Author's Response to Referee Comment #2 by Dr. Micha Werner

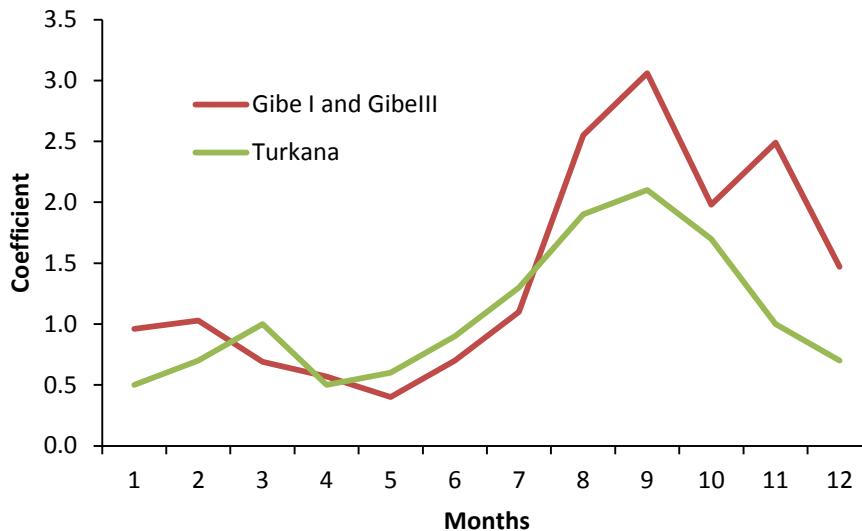
13. P3003-P3004: *In the hypothesis of why the lake would stabilise faster depending on the initial water levels because of the smaller inflows does not fully make sense to me. Volumetrically there is no dependence of the inflow on the lake levels. I agree that the level increment depends on the area of the lake, but does this mean it stabilises quicker? I think that the evaporation from the lake and its dependence on the lake area also needs to be considered, and suggest the authors revisit this paragraph after looking carefully at the influence of evaporation.*

Response: The impact of initial lake levels is mainly because of the lake elevation-area-volume curve. This shows the combined effect of the regulated/moderated lake inflows into the lake and evaporation losses from the reservoir. To explain this phenomenon clearly, let us assume two cases as shown below:

Case 1: Lake is at higher initial lake level

Without Gibe III: The lake would receive unregulated inflows (with an average flow of 650 m³/s) that would compensate most of the ET losses and hence lake levels would show little reduction in lake levels.

With Gibe III: The lake would receive regulated minimal inflows (with an average flow of 400 m³/s) especially during the first impoundment period and since at higher lake level, larger volume of inflows are required to compensate the ET losses, the lake levels will decline rapidly when compared to without Gibe III. Hence the impact (different between without and with Gibe III) is higher at higher initial lake level

Case 2: Lake is at lower lake level

Without Gibe III: The lake would receive unregulated inflows (with an average flow of 650 m³/s) that would compensate ET losses from a smaller surface area and hence lake levels would show little reduction in lake levels.

With Gibe III: The lake would receive regulated minimal inflows (with an average flow of 400 m³/s) and since at low lake level, smaller volume of inflows are enough to compensate most of the ET losses, the lake levels will decline at a smaller rate when compared to without dam. Hence the impact (different between without and with dam) is lower at higher initial lake level
